**PLANNED UNIT DEVELOPMENT
& SUBDIVISION STAFF REPORT****Date: September 7, 2006****DEVELOPMENT NAME**

Willard Subdivision, First Addition, Resubdivision of Lots 3 & 4, and Resubdivision of Lots "A" & "B" of the Resubdivision of Lots 1 & 2, Lot 2

CONTEMPLATED USE

Subdivision approval to combine two lots of record into one lot and adjust existing buffer and drainage/utility easements for all included lots, and Planned Unit Development approval to allow three warehouse buildings and one office building on a single building site.

PLANNING COMMISSION VICINITY MAP - EXISTING ZONING

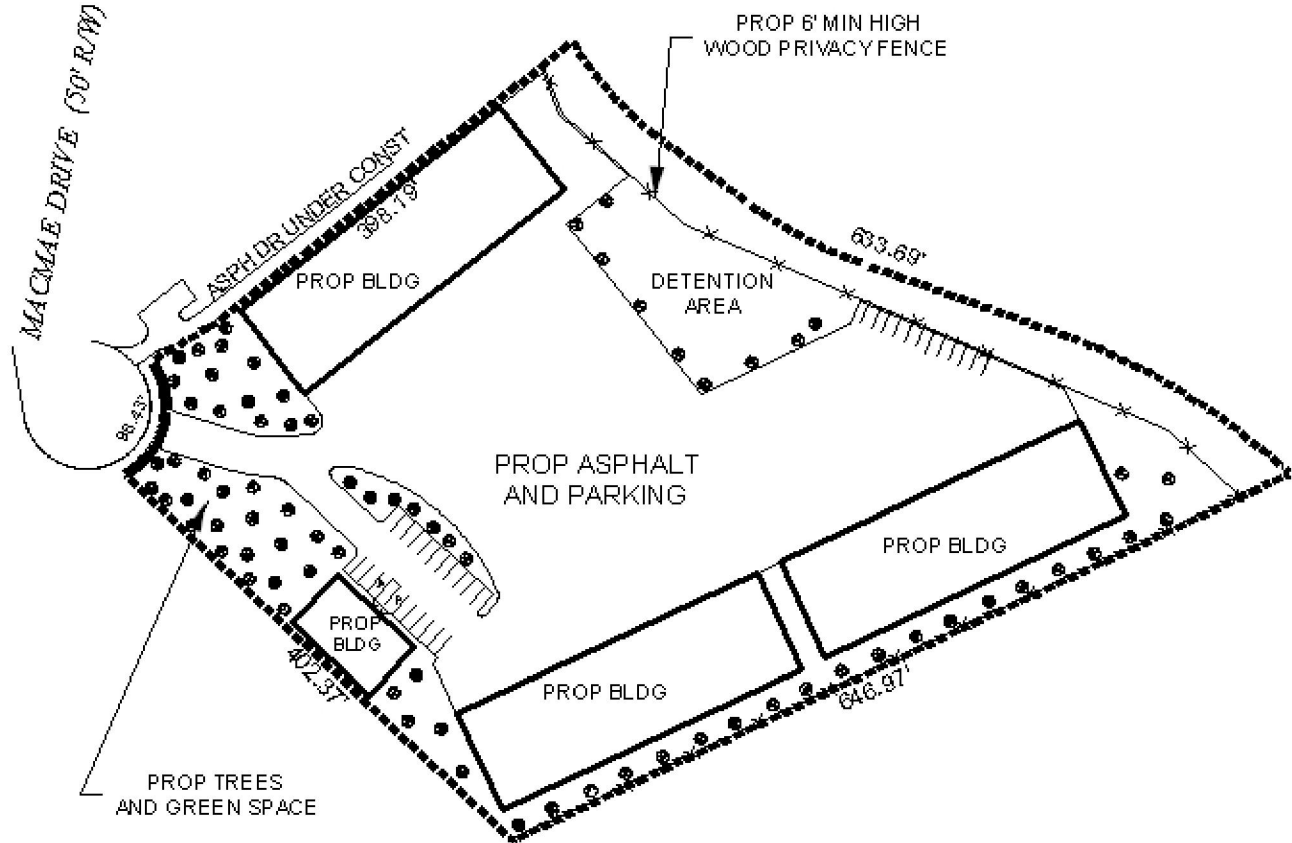
The application for Planned Unit Development approval specifically relates to the new lot that will be created by the combination of existing lots 2 and 3. The site will be developed to include a 4,000 square foot office building and three 20,000 square foot warehouse buildings, for a total of 60,000 square feet of warehouse space. As designed, the development exceeds all landscaping and parking requirements, and all buildings are a minimum of 25-feet from adjacent residential development. The required stormwater detention is depicted on the site plan. It should be noted that some calculations on the site plan appear to be incorrect. It appears that the parking calculations list one parking space less than is actually depicted on the site plan. It also appears that the site plan depicts one more tree than has been included in the landscape calculations. The site plan and calculations should be revised so that they are in agreement.

As the proposed new development will be adjacent to existing residences, the applicant should ensure that any lighting provided on the site will comply with the Zoning Ordinance requirement that states that lighting *"shall be so arranged that the source of light does not shine directly into adjacent residential properties or into traffic."* A note should be placed on the PUD site plan reflecting the Zoning Ordinance lighting requirement.

Finally, there is no indication on the site plan as to the proposed location of any dumpster or other waste storage facility. If the applicant utilizes a dumpster, the location of the storage area for the dumpster must be indicated on the site plan, and the location and required screening must comply Section 64-4.D.9. of the Zoning Ordinance, as well as with all other applicable regulations.

SUBDIVISION PLAT

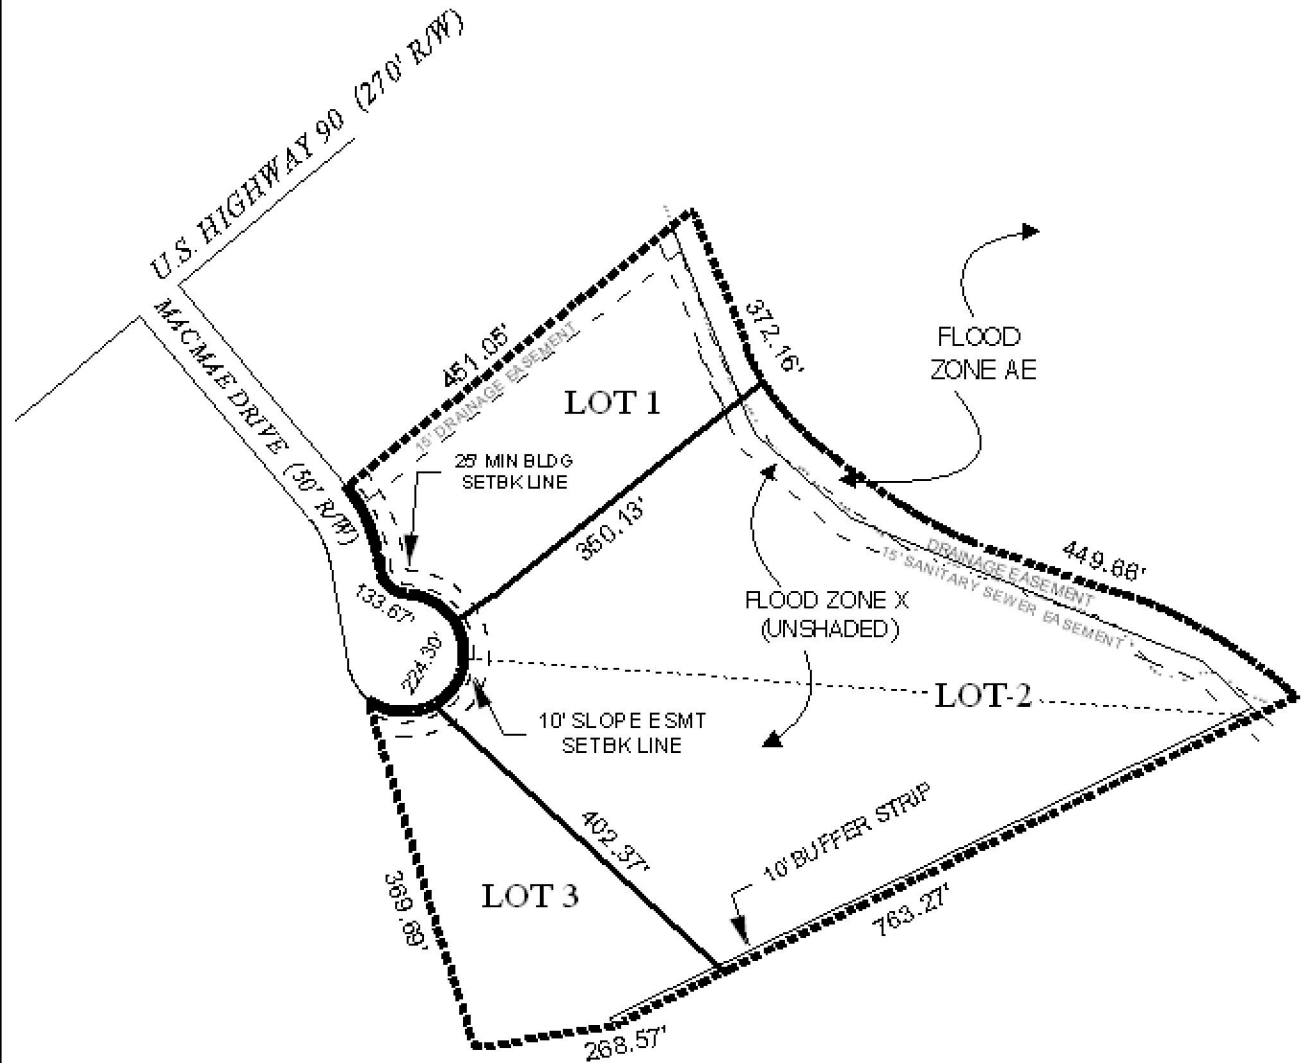
Recommend NO reduction of drainage easements due to the existence of an outfall pipe from Macmae Drive. When the outfall requires maintenance, the full width will be required for probable excavation and vehicle access. The easement along Bolton's Branch is necessary for maintenance vehicles. In addition, the sanitary sewer easement should not be reduced without the approval of the MAWSS.

The purpose of this application, as it relates to Subdivision approval, is to combine the existing lots 2 and 3 into one lot, and to reduce the 75-foot buffer strip depicted on the South and East sides of existing lots 1-4 to 10 feet along the South property line, and to varying widths along the East property line (essentially to conform to the existing drainage easement width of

approximately 20 feet). It also appears that the existing 25-foot drainage/utility easement along the North side of lot 1 will be reduced to 15 feet, and the existing sanitary sewer easement along the East side of existing lots 1 and 2 will be reduced from 20 feet to 15 feet.

Engineering has recommended that all existing drainage easements be kept at their current size. Engineering also indicates that the area generally has drainage problems, thus development on the site must fully comply with the stormwater management and flood control requirements.
